Section : Pre-Delivery
 Ref. No. : PD-0008
 Date : April 2000
 Page : 1 of 1

Model Name : RAV4

Subject : CUT FUSE INSTALLATION DURING PDS

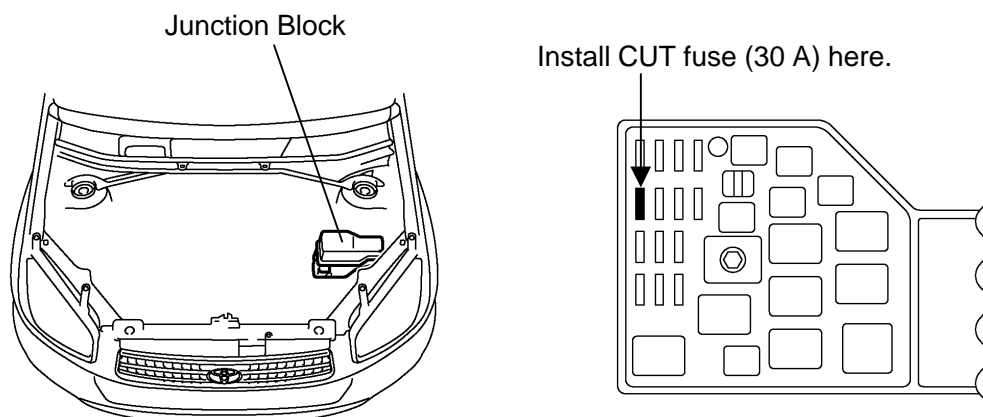
This is to inform you that the CUT fuse has been removed on the RAV4 at assembly plant to reduce parasitic current draw in transit and storage.

The removed CUT fuse (30 A) is stored on the back of the Junction Block cover in the engine compartment.

The CUT fuse must be reinstalled during PDS (Pre-Delivery Service) in dealership as shown below.
